**Subject: MHI's Response to US-APWR DCD RAI No. 383-3002 REVISION 1**

**Response to Request for Additional Information  
No. 383-3002 Revision 1**

**RAI NO.:** NO. 383-3002  
**SRP SECTION:** 10.04.06 - CONDENSATE CLEANUP SYSTEM  
**APPLICATION SECTION:** 10.4.6  
**DATE OF RAI ISSUE:** 06/08/2009

Fig. 4 Na concentration vs crevice pHt when Na alone increases  
(Concentration rate = 10<sup>5</sup>)

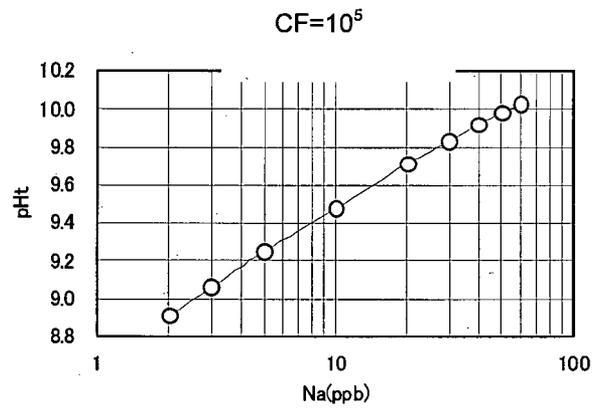
Sodium. Fig. 3-4 indicates  $\text{pH} \geq 10$  when  $\text{CF} \geq 107$  (using the bulk concentration of 1 ppb from Table 3-1). Hence, for  $\text{CF} = 105$  as claimed by applicant, the analogous bulk concentration would be 100 ppb, which is less stringent than applicant's value of 50 ppb for a limit.

Fig. 4 shows the Na concentrations when Na alone increases under the condition of concentration rate of  $10^5$  vs the crevice pHt (evaluation code calculation result). The crevice pHt thereby would be 10 or more at Na concentration of 50 ppb or more. Therefore, the value of 50 ppb is set as the control upper-limit value for Na concentration in the operation mode of less than plant load 30%.

Fig. 5 SO<sub>4</sub> concentration vs crevice pH when Na co-exists (Concentration rate = 10<sup>5</sup>)

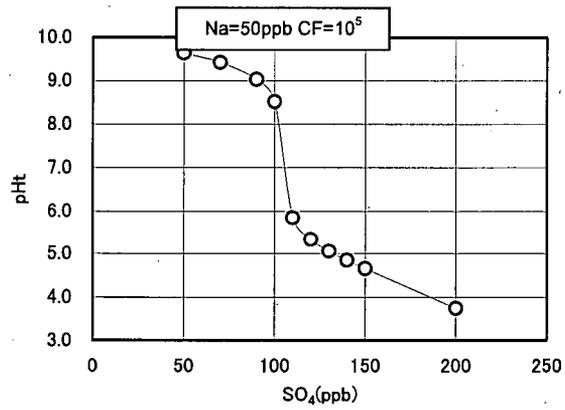
Sulfate. Fig. 3-7 indicates  $\text{pH} \leq 5$  when  $\text{CF} \geq 106$  (using the bulk concentration of  $3[\text{Na}] = 3$  ppb from Table 3-1). Hence, for  $\text{CF} = 105$  as claimed by applicant, the analogous bulk concentration would be 30 ppb, which is more stringent than applicant's value of 100 ppb for a limit.

Fig. 5 shows the behavior of crevice pHt (evaluation code calculation result) when  $SO_4$  concentration is increased while 50 ppb of Na co-exists under the condition of concentration rate of  $10^5$ . If  $SO_4$  concentration becomes 100 ppb or more, thereby, crevice pHt drops rapidly to 5 or less. Consequently, 100 ppb is set as the control upper-limit value for  $SO_4$  concentration in the operation mode of less than plant load 30%.

Fig. 6 Cl concentration vs crevice pH when Na co-exists (Concentration rate = 10<sup>5</sup>)

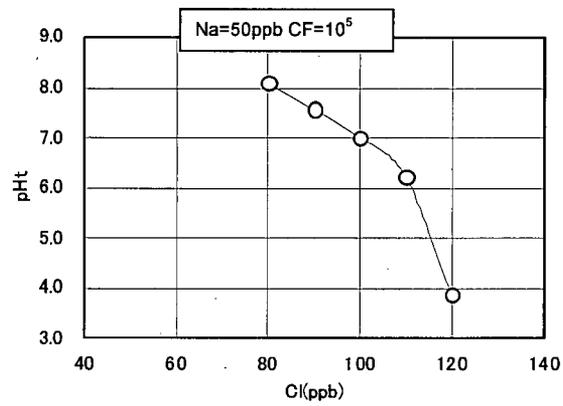
Chloride. Fig. 3-6 indicates  $\text{pH} \leq 5$  when  $\text{CF} \geq 2.5 \times 10^5$  (using the bulk concentration of 4.6 ppb from Table 3-1). Hence, for  $\text{CF} = 105$  as claimed by applicant, the analogous bulk concentration would be 10 ppb, which is much more stringent than applicant's value of 100 ppb for a limit.

Fig. 6 shows the behavior of crevice pHt (evaluation code calculation result) when Cl concentration is increased while 50 ppb of Na co-exists under the condition of concentration rate of  $10^5$ . If Cl concentration becomes 100 ppb or more, thereby, crevice pHt drops rapidly to 5 or less. Cl, on the other hand, affects the drop of crevice pHt, and Cl itself provides causes of pitting in its co-existence with oxidizing agents. Concentration, in which Cl does not affect the materials of SG heat transfer tube soundly, is 100 ppb as shown in Fig. 7 (Reference 3). From the viewpoint of preventing the occurrence of these damages, 100 ppb is set as the control upper-limit value for Cl concentration in the operation mode of less than plant load 30%, by reflecting both conditions.
